**SEDALIA REGIONAL AIRPORT (DMO)
SEDALIA, MISSOURI**

MoDOT Project No. 20-020A-2

**Project Description
Construct Box Hangar**

ADDENDUM NO. 3

HANGAR ELECTRICAL PLANS

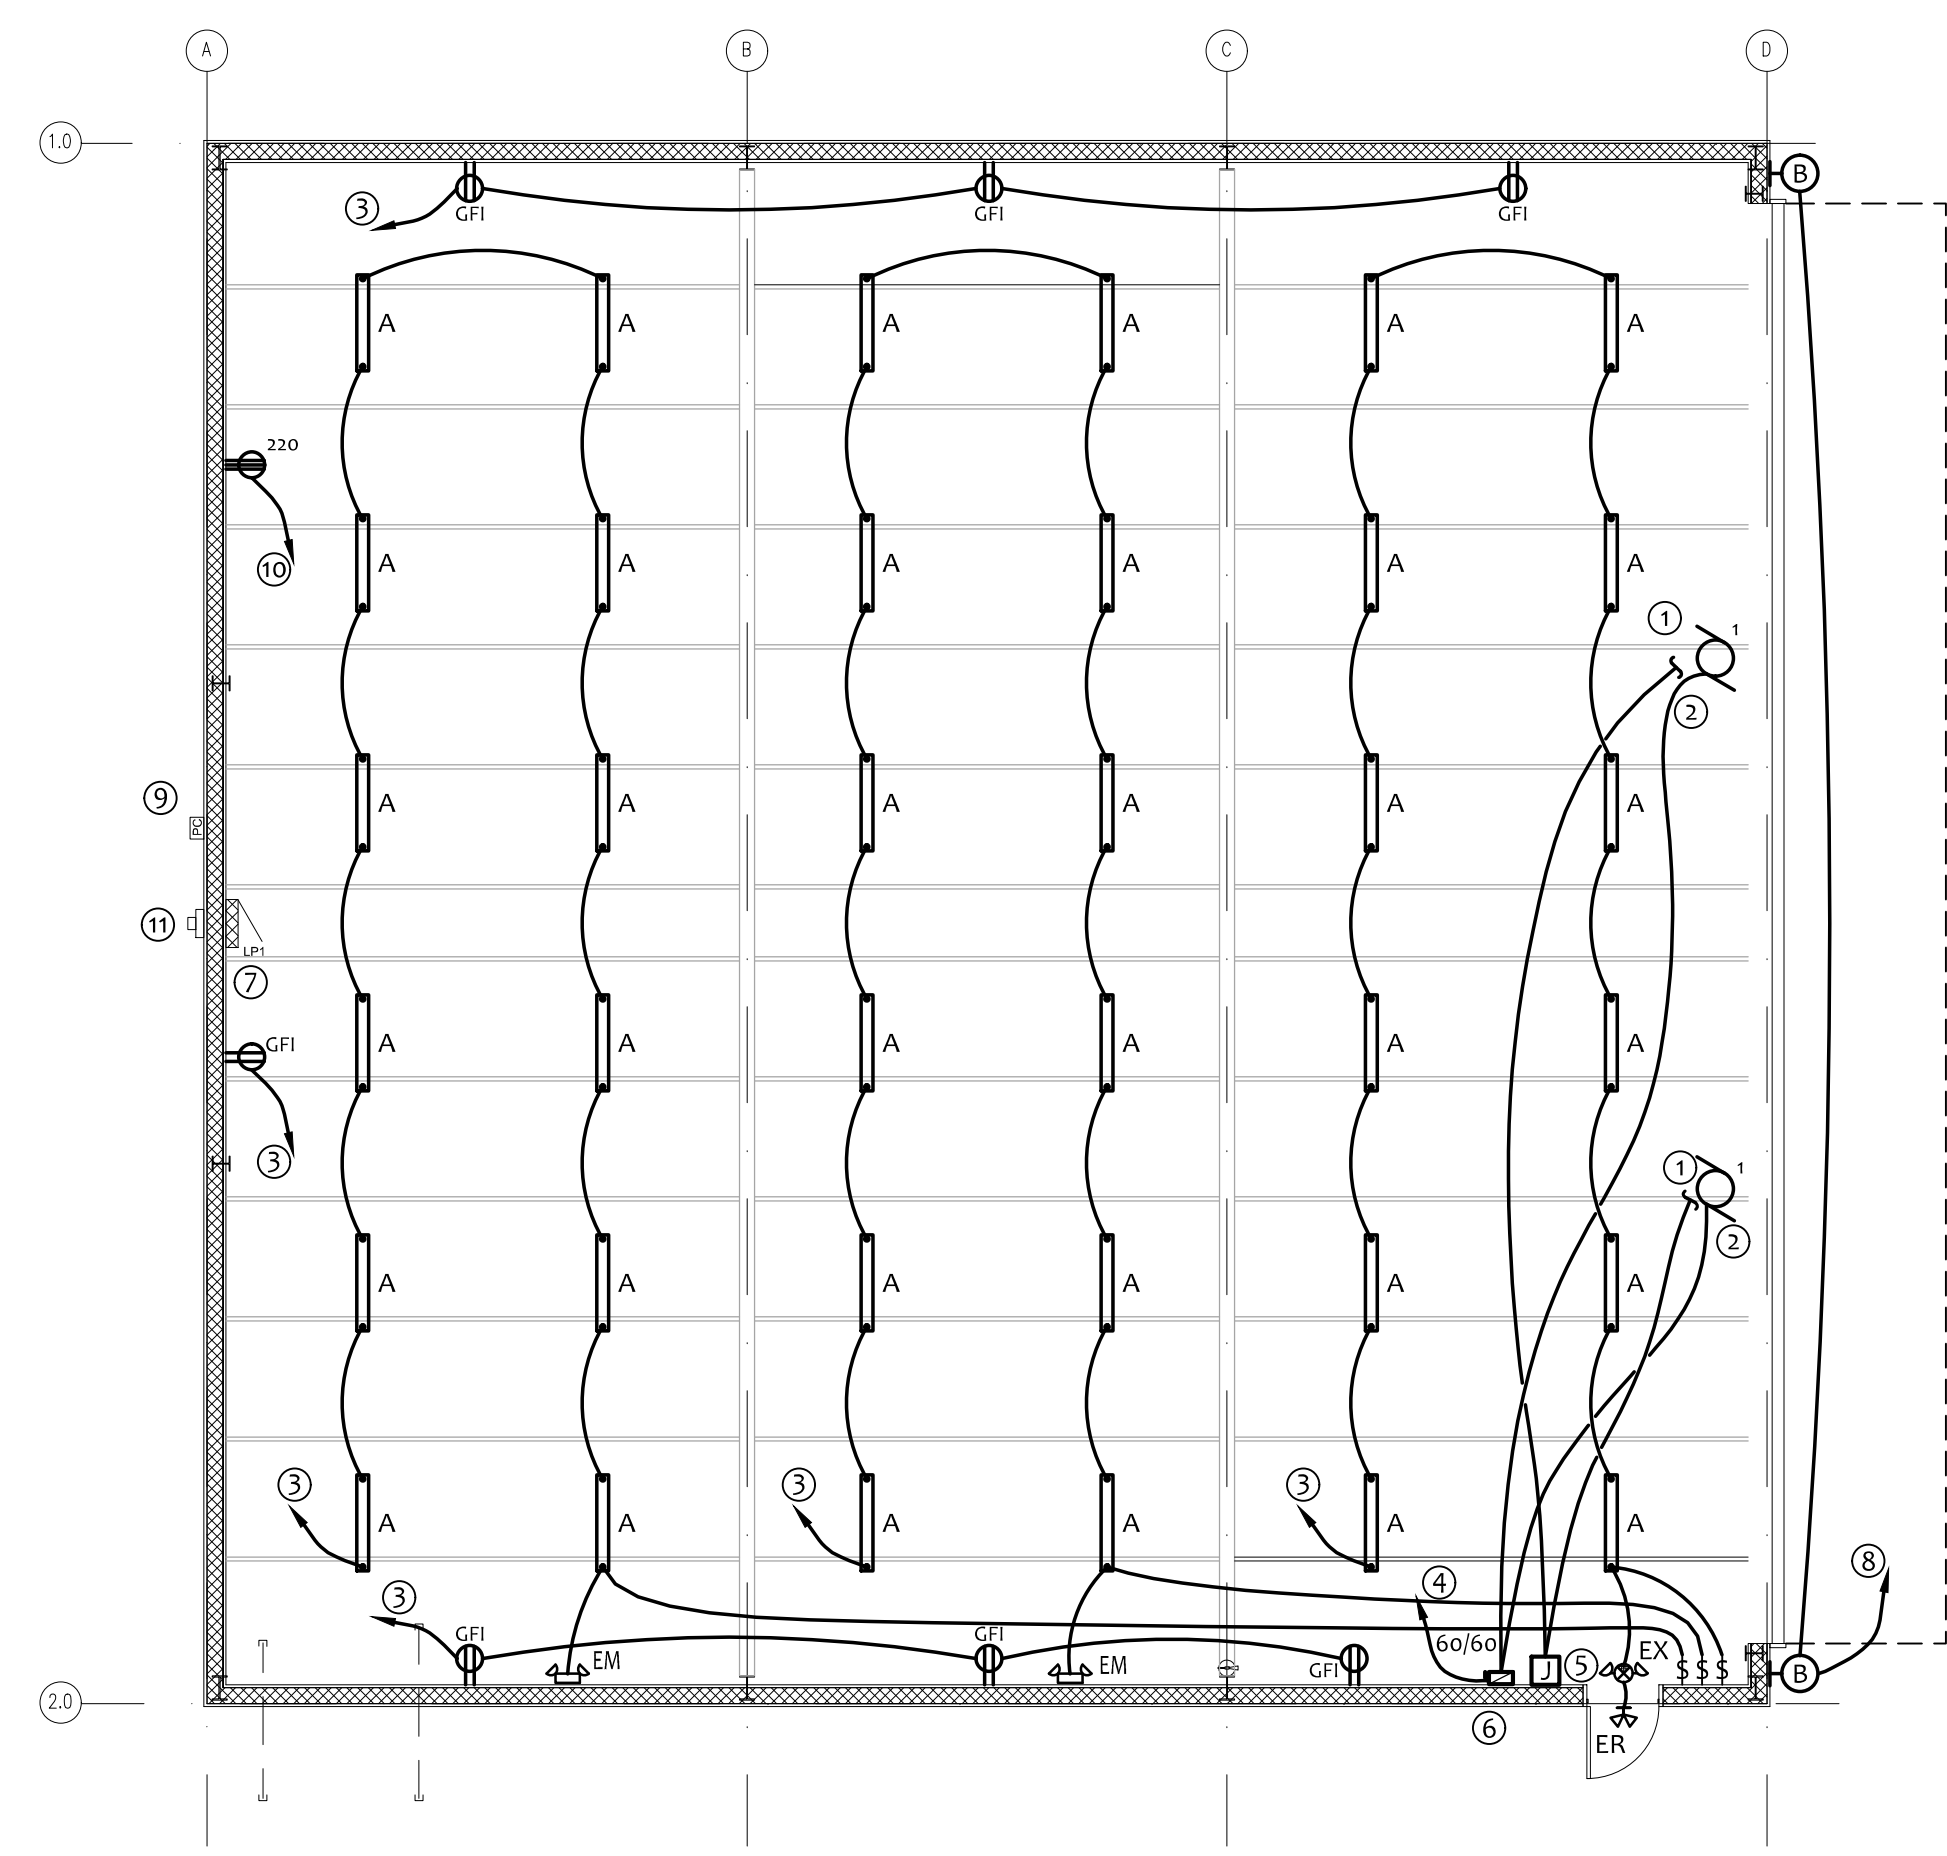
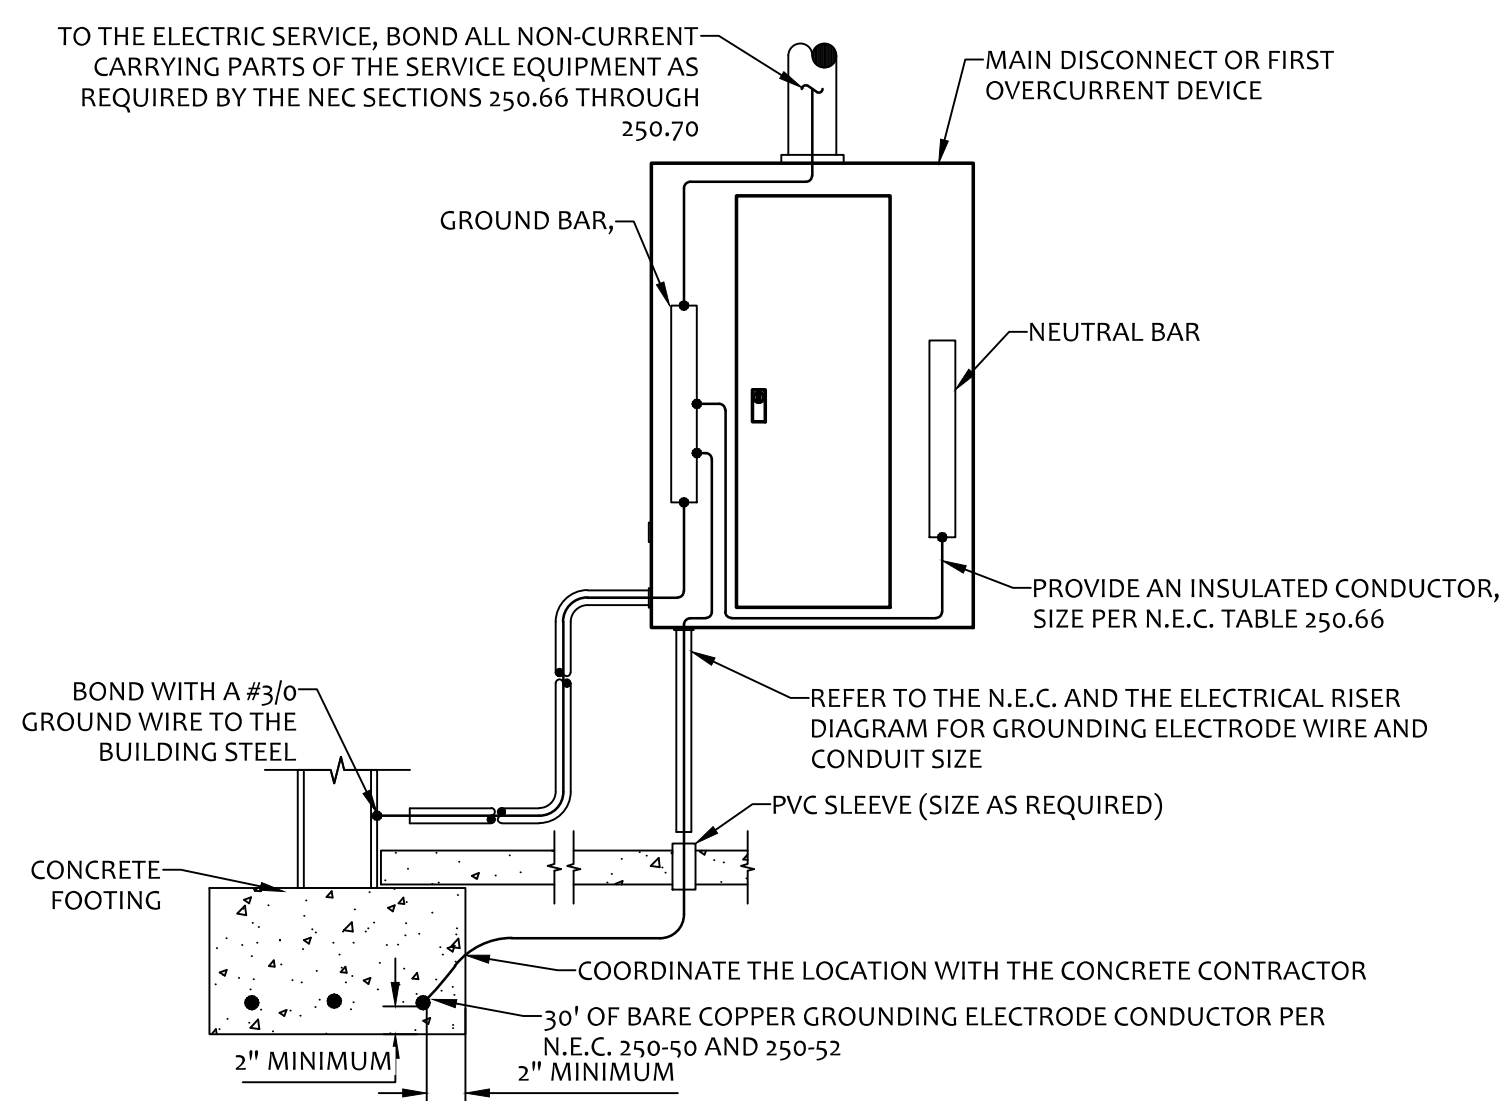
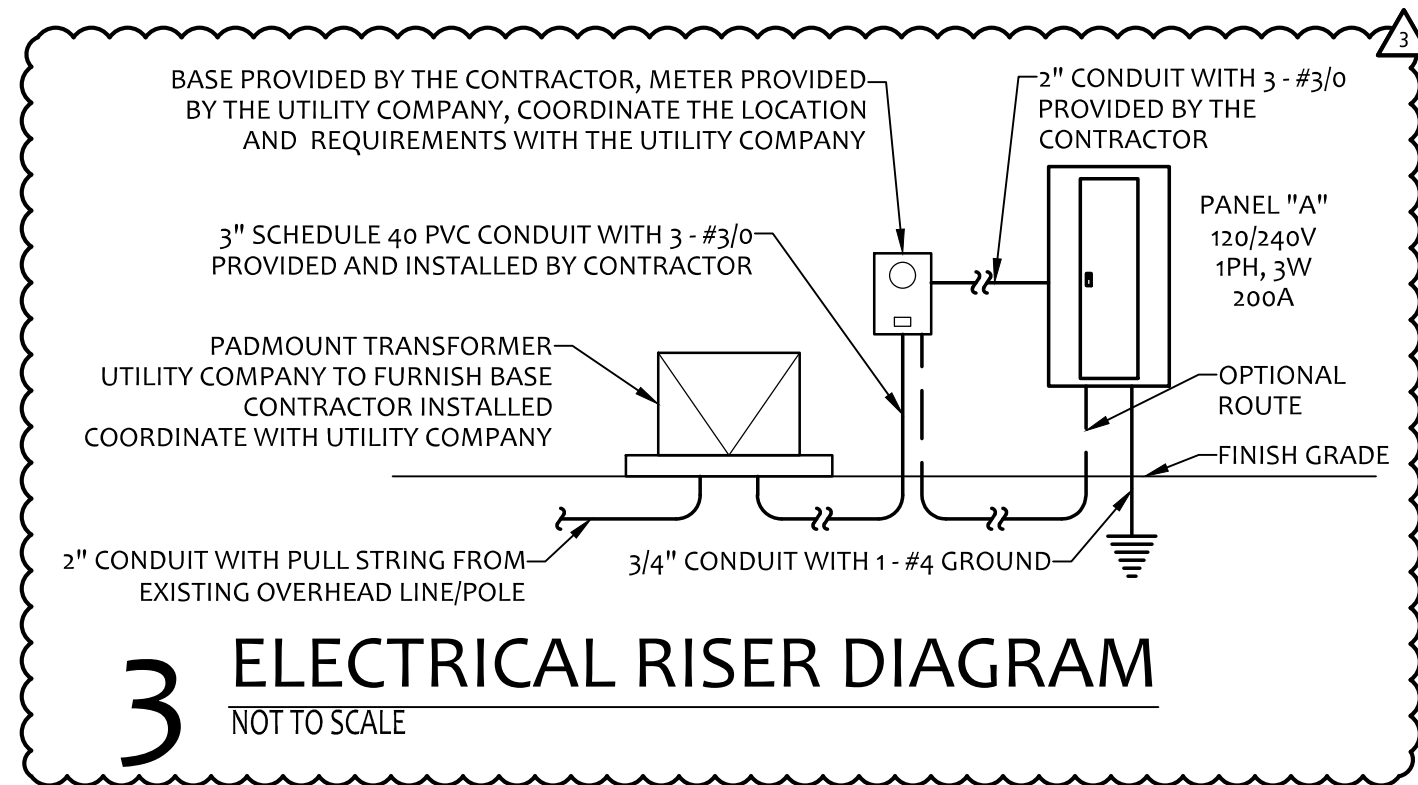
2. Sheet E1, Hangar Electrical Plans. Detail 3 “Electrical Riser Diagram” has been revised to reflect the installation layout and responsibility coordination with Evergy for service to the hangar. Please note that the 2” conduit with pull string that the contractor shall furnish and install from the existing

overhead line/pole to the transformer is approximately 350' in length. All electrical work performed by the contractor is still subsidiary to construction of the hangar itself.

3. Sheet E1, Hangar Electrical Plans. MEP General Notes O. and P. have been added for clarification.
4. Sheet E1, Hangar Electrical Plans. Key Note 10 has been revised to change the size of the conductors called out.
